# Service Bulletin

Bulletin No.: PI1088

**Subject:** Information on Proper Auxiliary Power Connections

**Models:** 2011-2014 Chevrolet Caprice PPV  
Equipped with Auxiliary Battery RPO K4S or K5S

3634969

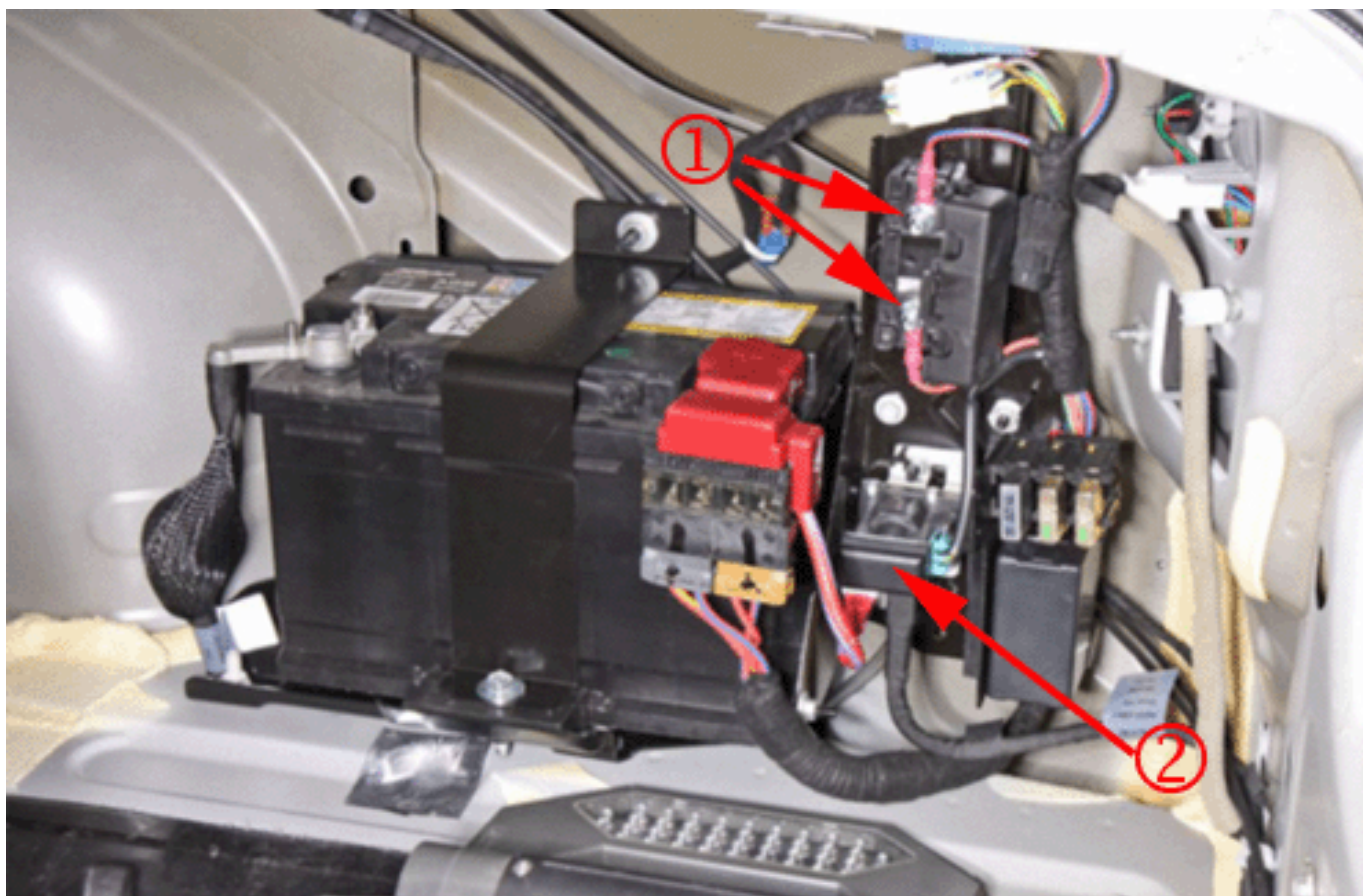
Improper electrical connections using the power studs on the isolation relay rather than the provided power studs. Any added power circuit in the trunk electrical center should not utilize the studs on the isolation relay.

The Caprice PPV equipped with the auxiliary battery utilizes an isolation relay to protect the auxiliary battery from being discharged during engine starting. To eliminate the possibility of improper power tapping, refer to the image below to identify the location of the proper power taps on vehicles equipped with the auxiliary battery, which is located in the trunk of the vehicle directly behind the RH wheel.

- (1) Auxiliary Power Taps (shown with cover open)
- (2) Isolation Relay - DO NOT use as power taps
